# Permit of Authorization to Construct an On-Site Sewage Facility Permit Valid For One Year From Date Issued

Permit Number: 118556

709 BURR OAK LN

# On-Site Sewage Facility Application and Design

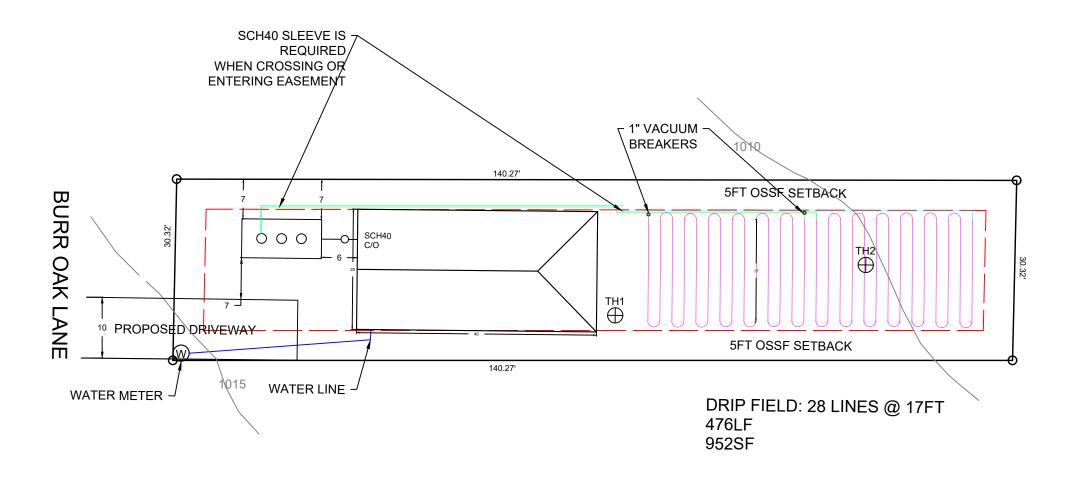
I am requesting a variance to allow for the installation of a 1" supply and return manifold that encroaches into the property easement as well as the OSSF Setback from the property line due to space constraints and the overall design of the site. To ensure compliance with TCEQ Chapter 285, the manifold will be sleeved where it crosses into the OSSF Setback & Easement, providing equal protection and preventing harm to the environment or the OSSF system components. I believe this modification will not negatively impact the system's functionality or public health standards.
